**Town of Kittery
Planning Board Meeting
July 13, 2023**

ITEM 1– 35 Badgers Island West, Preliminary Site Plan and Shoreland Development Plan

**Re: Preliminary Site Plan Review Application; Conversion to Residential
Tax Map 1, Lot 32, 35 Badgers Island West**

GRADING PLAN **C4**

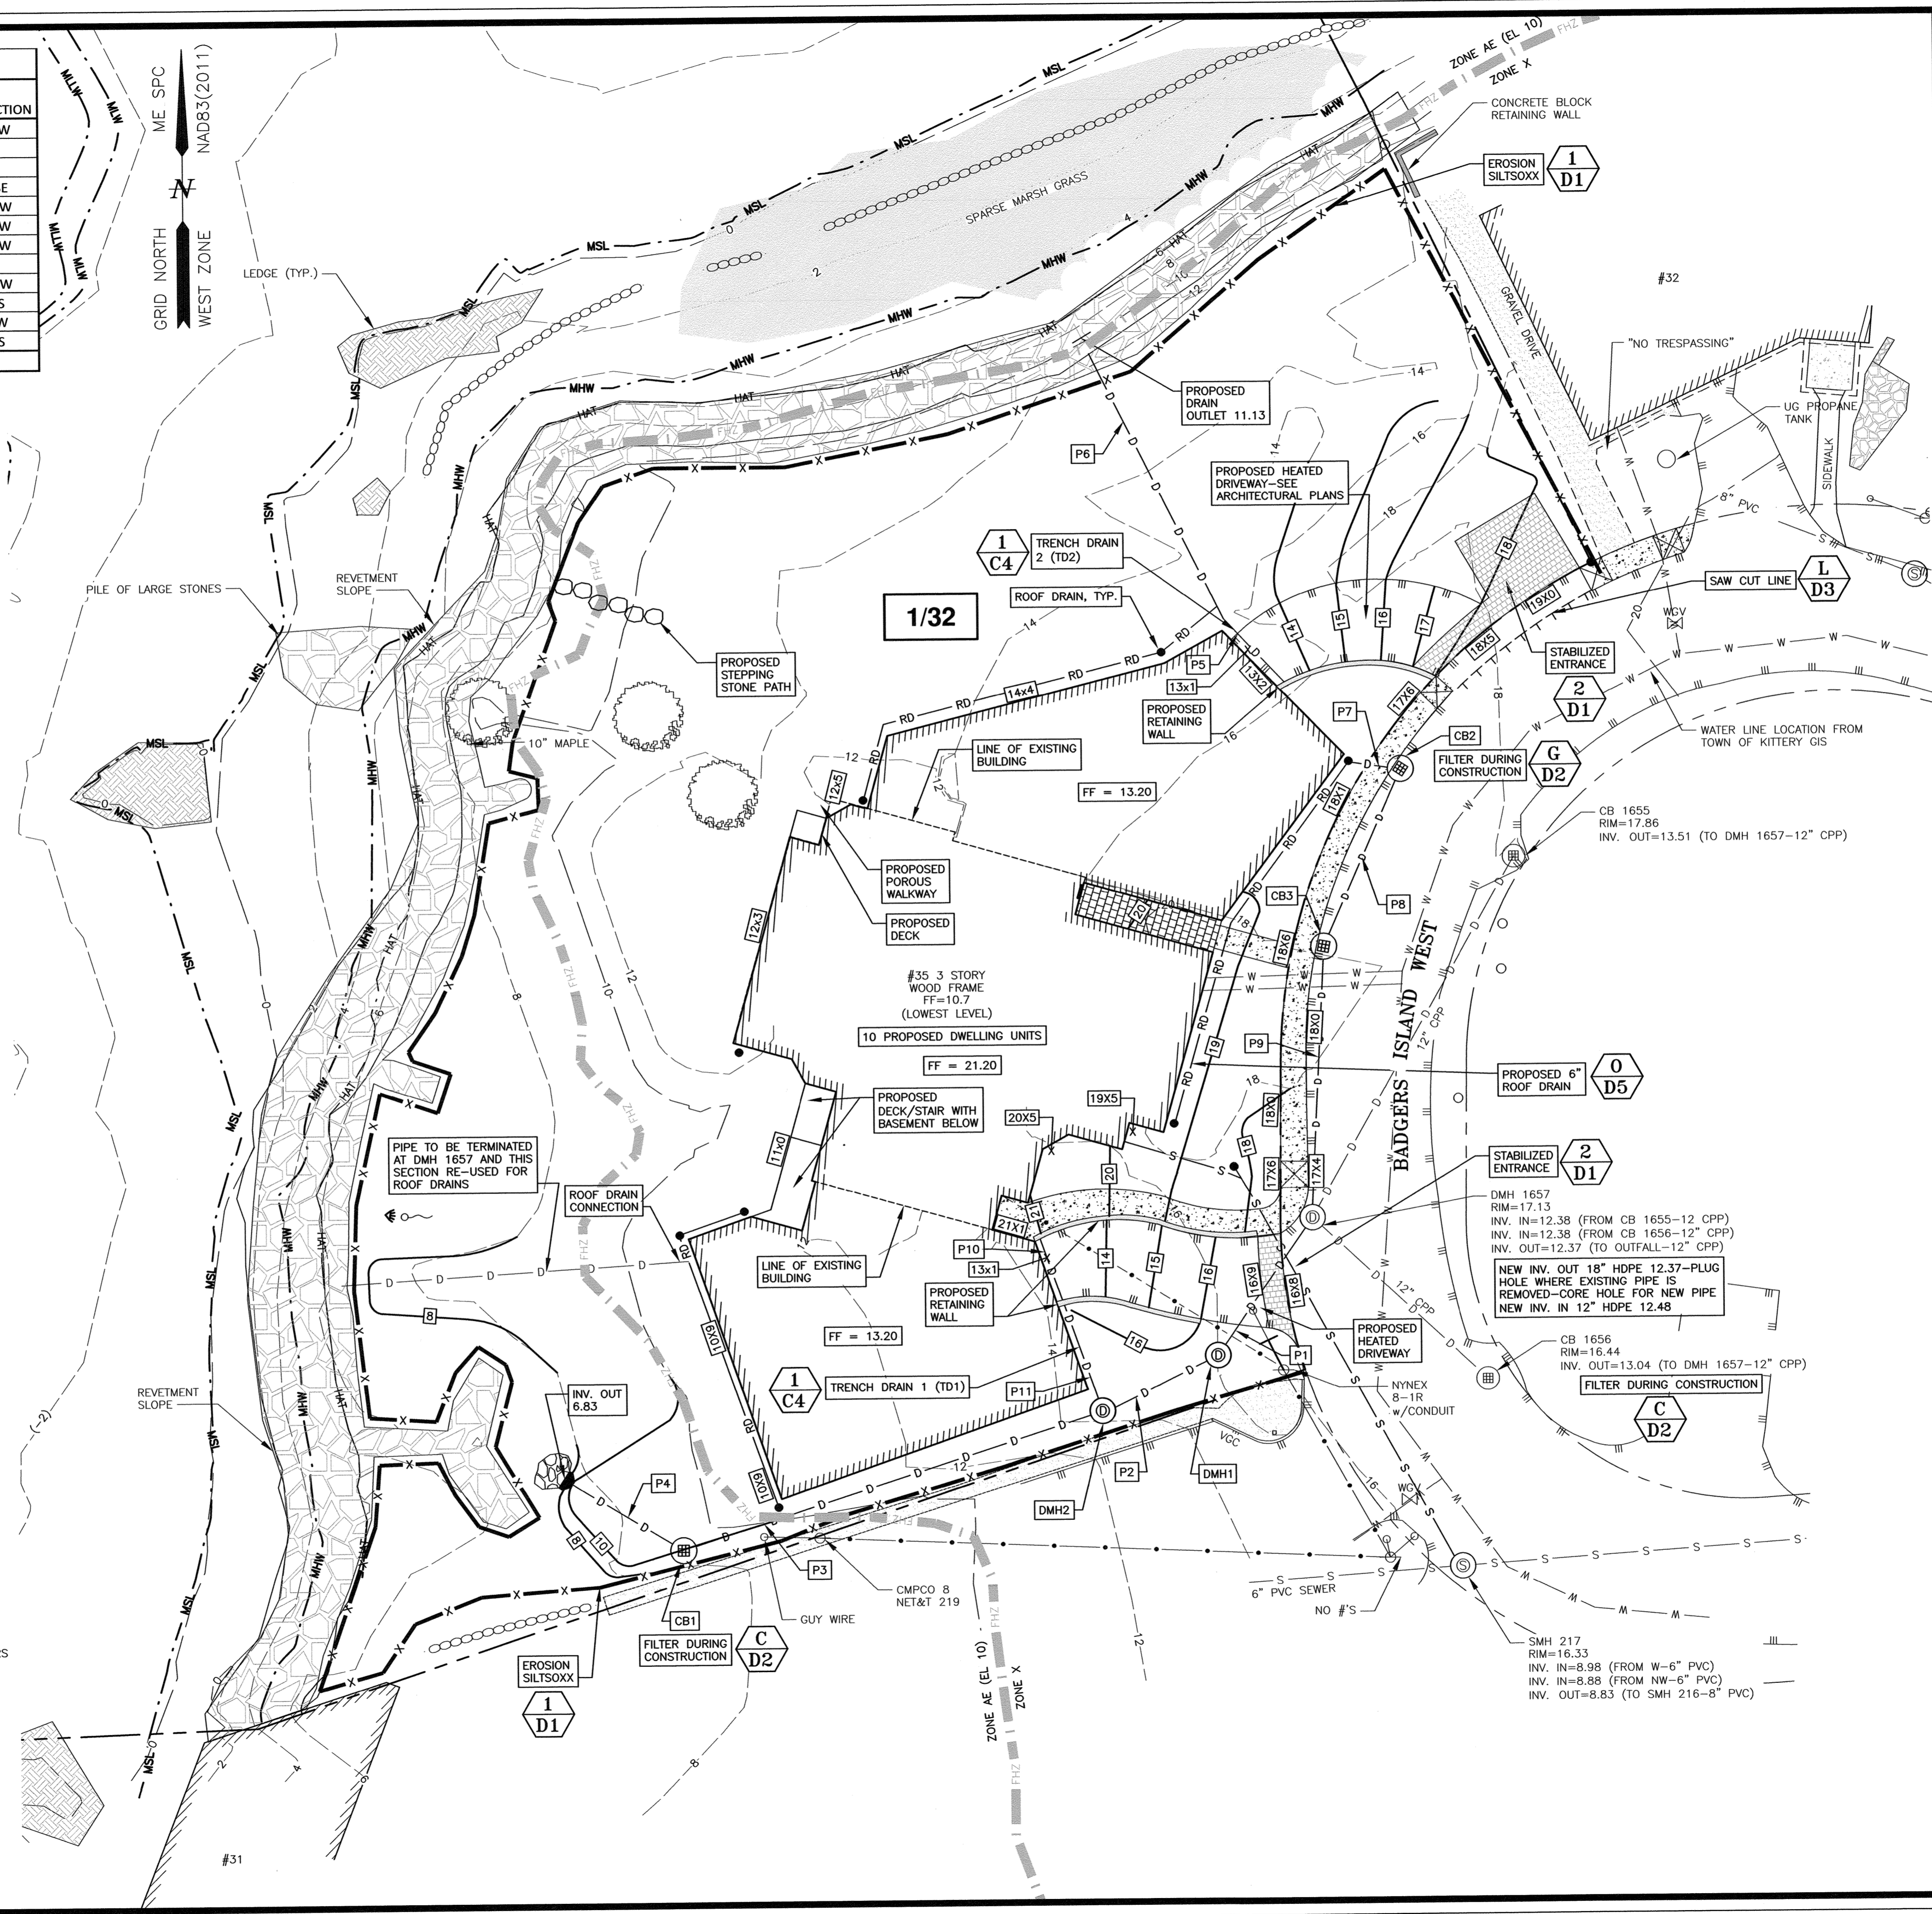
8. DMH2 in the Drainage Structure Schedule on Sheet C4 is missing the invert in for P8. **Added.**
9. CB2 does not have an invert out in the Drainage Structure Schedule on Sheet C4. **This has been shown (number was in the wrong column).**

DEMOLITION PLAN **C5**

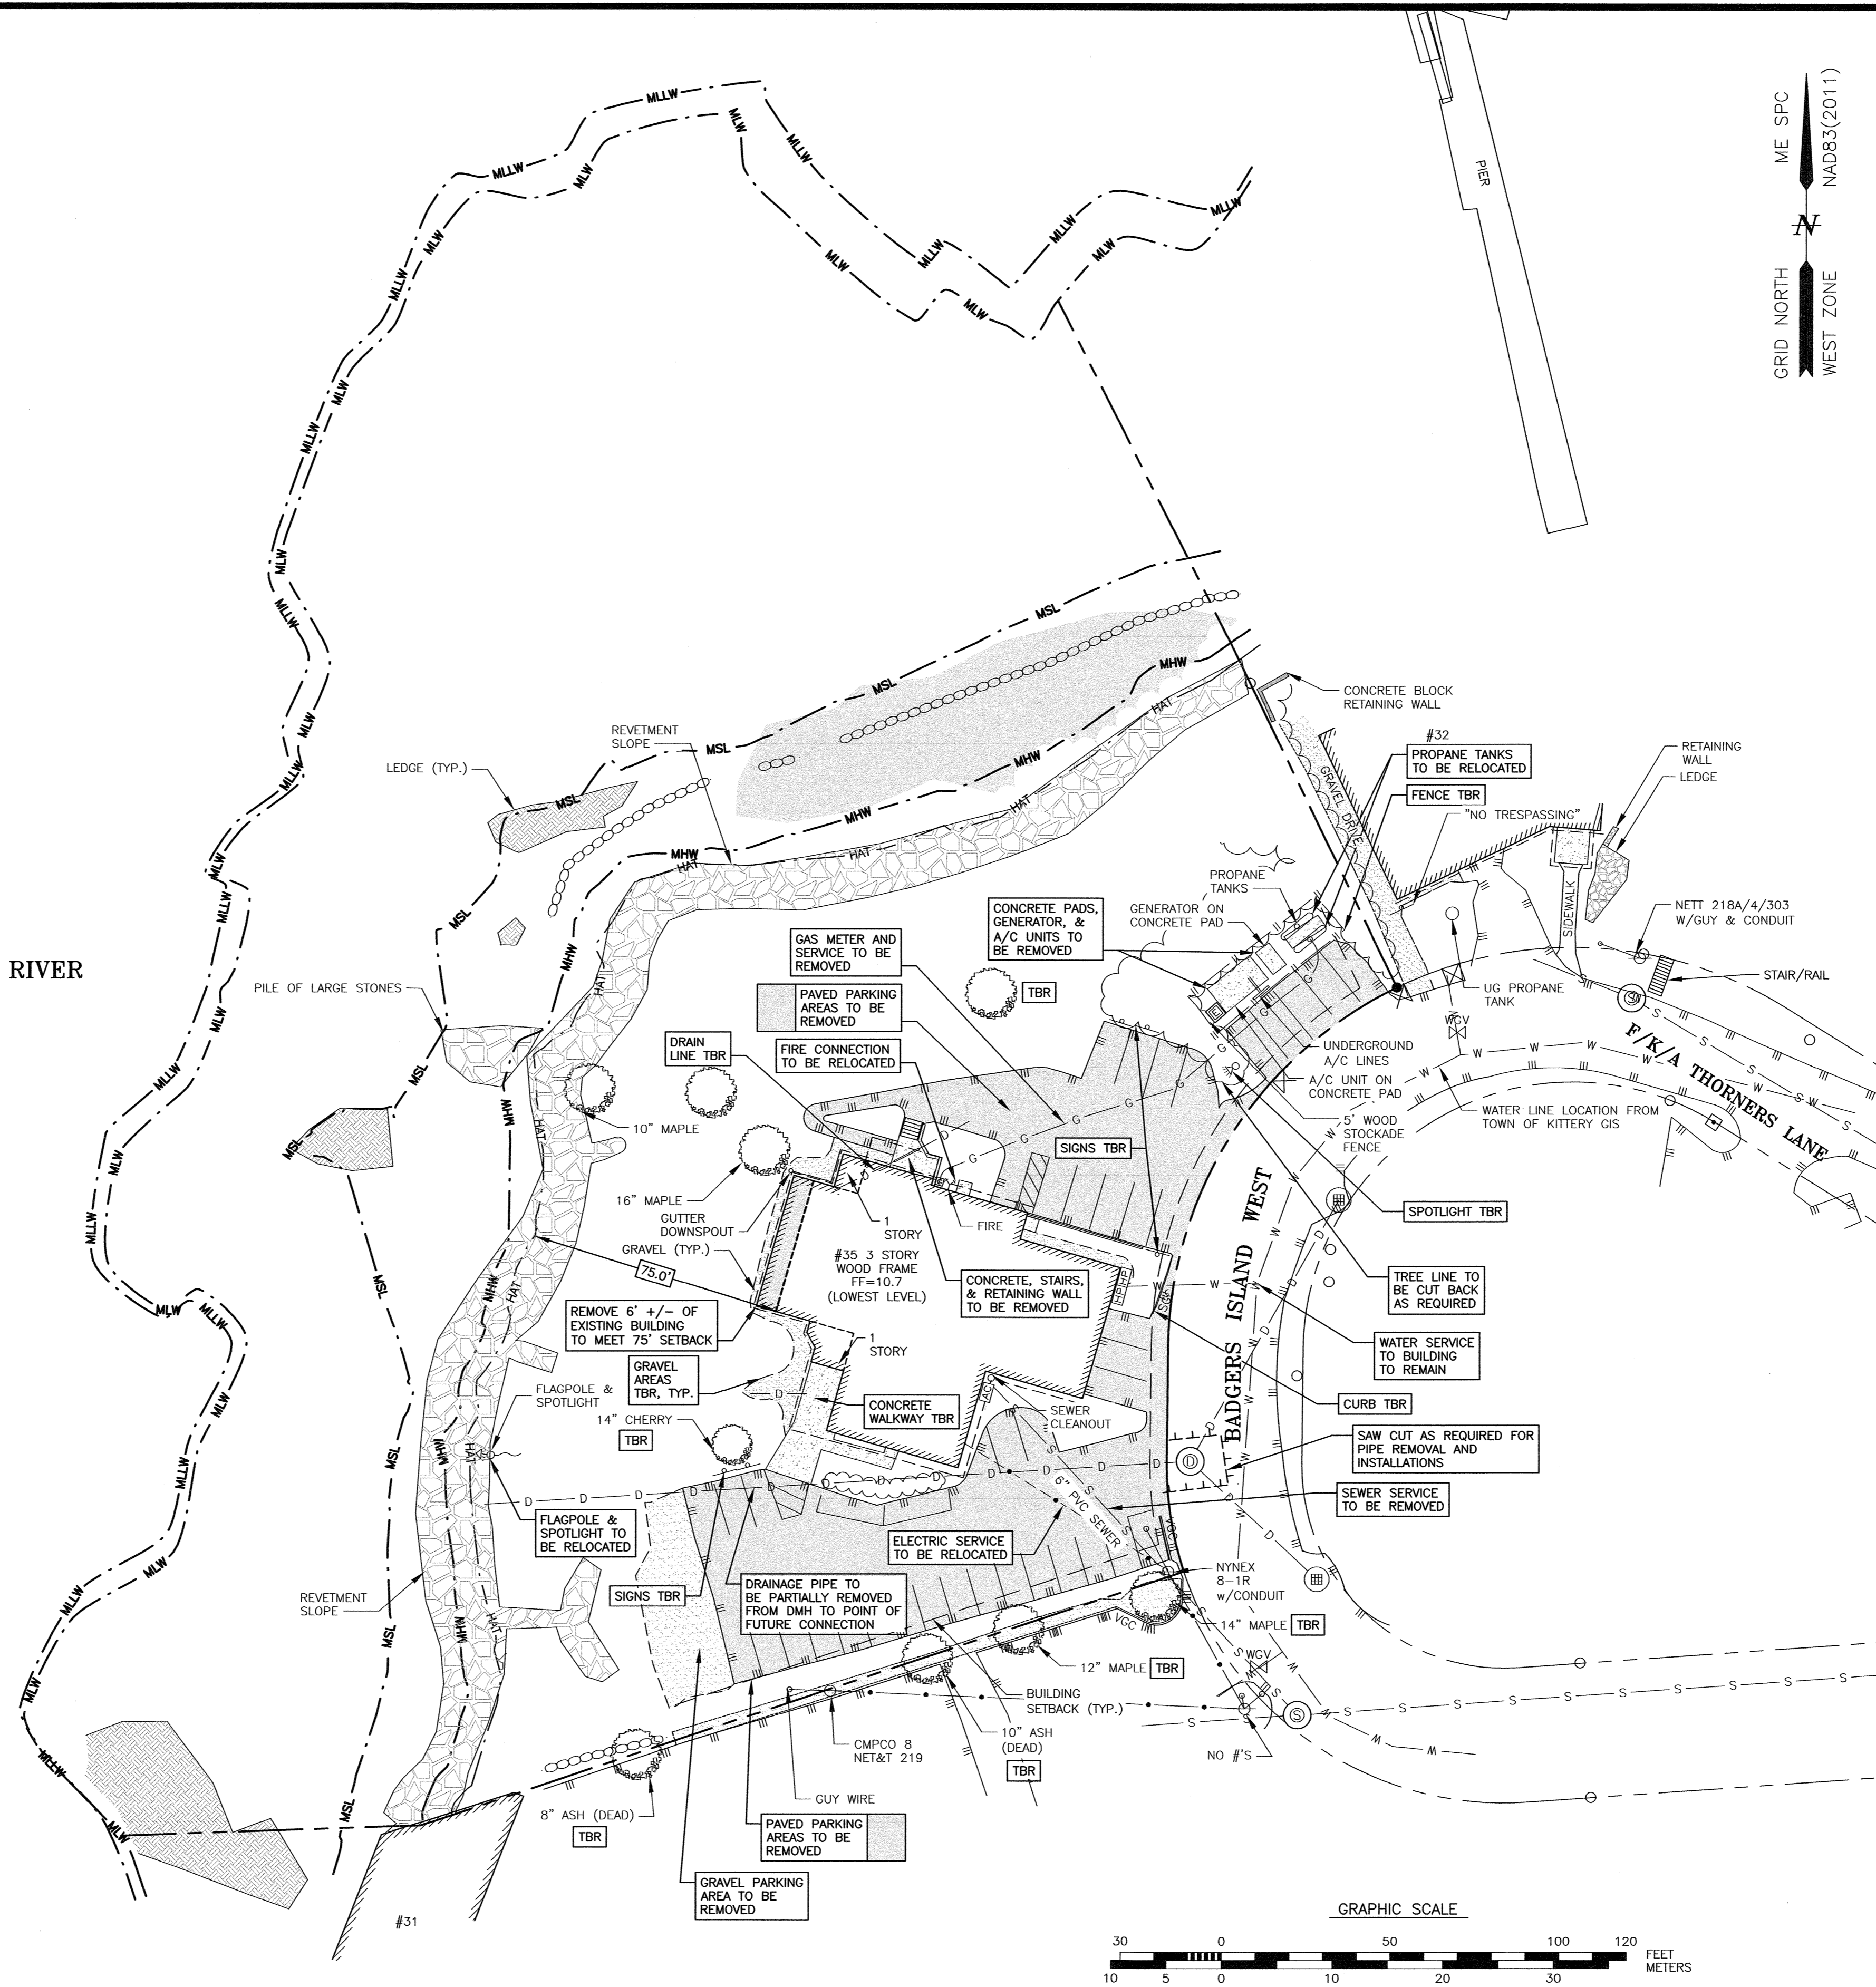
1. There is a leader indicating “Sewer Service to Remain” but Sheet C3 indicates it is to be relocated. **Noted to be REMOVED.**
2. The existing drainage pipe that is to be partially removed should be shown and called out to be removed on the plan. **Done.**
3. The plans indicate that the “Gas...Service to be Relocated” but it is not shown elsewhere on the plans. **Gas service will be eliminated.**
4. The limit of demolition should be expanded to include new pipe connection to DMH 1657. **Done.**
